**COLORADO DIVISION OF RECLAMATION, MINING AND SAFETY**  
**MINERALS PROGRAM INSPECTION REPORT**  
**PHONE: (303) 866-3567**

<b>MINE NAME:</b> Gloria Z Mine	<b>MINE/PROSPECTING ID#:</b> M-1984-094	<b>MINERAL:</b> Sand and gravel	<b>COUNTY:</b> Park
<b>INSPECTION TYPE:</b> Monitoring	<b>INSPECTOR(S):</b> Michael A. Cunningham	<b>INSP. DATE:</b> August 30, 2012	<b>INSP. TIME:</b> 09:30
<b>OPERATOR:</b> Sanborn Sand and Gravel/dba Golden Cross Aggregate	<b>OPERATOR REPRESENTATIVE:</b> Mike Pfister	<b>TYPE OF OPERATION:</b> 112c - Construction Regular Operation

1. Area of re-exposed groundwater, facing south.

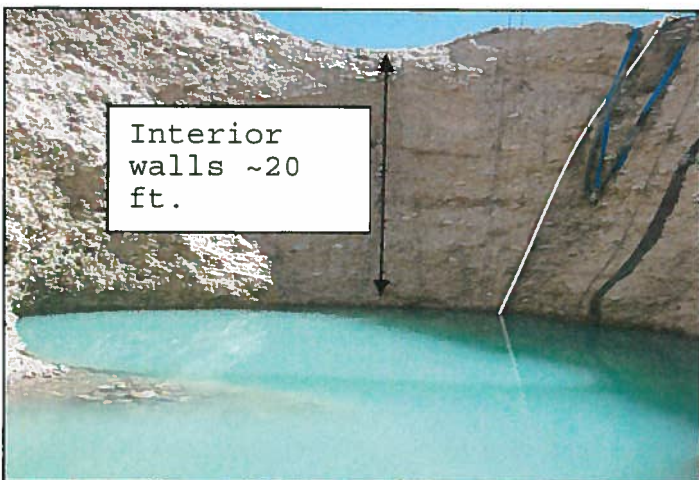
Following the previous inspection, the Operator was instructed to backfill the area of exposed groundwater located along the southern perimeter of the mine site to two feet above the static groundwater level or submit documentation demonstrating a legal right to expose groundwater. On August 23, 2012, the Operator submitted photographic documentation demonstrating the exposure of groundwater had been eliminated through backfilling. Upon arriving at the site the Division found that the Operator had re-exposed groundwater in the same location as was previously documented; the area of exposed groundwater was substantially larger than it was during the previous inspection. The area of exposed groundwater had increased from approximately 75 square feet to 6,500 square feet. In addition, the Operator had constructed a diversion ditch from the wash pond in the northern portion of the mine site to the area of exposed groundwater. The Operator explained that water from the wash pond was being diverted to the pit with exposed groundwater and the pit was being utilized as a settling pond. Mr. Pfister contended that the water in the pit was not groundwater, but was surface water which had been diverted from the wash pond. The Division disagrees with Mr. Pfister and, based on observations made during the inspection, has concluded the water in the pit is groundwater. No active mining operations were taking place during the inspection and no water was being diverted into the pit. The Operator did not submit a Technical Revision addressing the construction a diversion ditch or the use of the pit as a settling pond. These types of minor revisions require the submittal of a Technical Revision and the changes may not be made until the Division approval is granted.

In addition to re-exposing groundwater at the south end of the site, the Operator had exposed a second area of groundwater immediately west of the existing wash pond. The second area of exposed groundwater was approximately 300 square feet in size. According to Mr. Pfister, it was necessary to expose groundwater in this area because he could no longer make use of his water right, which allowed him to divert water from the Sacramento Creek to his wash plant. The Operator had set up a pump to move water from the pit up to the trommel located on the south side of the wash pond. The second area of exposed groundwater had vertical highwalls on three sides which were approximately 20 ft. in height. According to Mr. Pfister, the water was being leased and the evaporative depletions were covered under an existing augmentation plan. Mr. Pfister has not provided the Division with documentation demonstrating that he is in compliance with Colorado water laws and regulations governing injury to existing water rights. In addition, the Operator did not receive Division approval through a technical revision to expose a second area of groundwater. The approved Mining Plan for the Gloria Z clearly states that groundwater will not be exposed during mining operations.
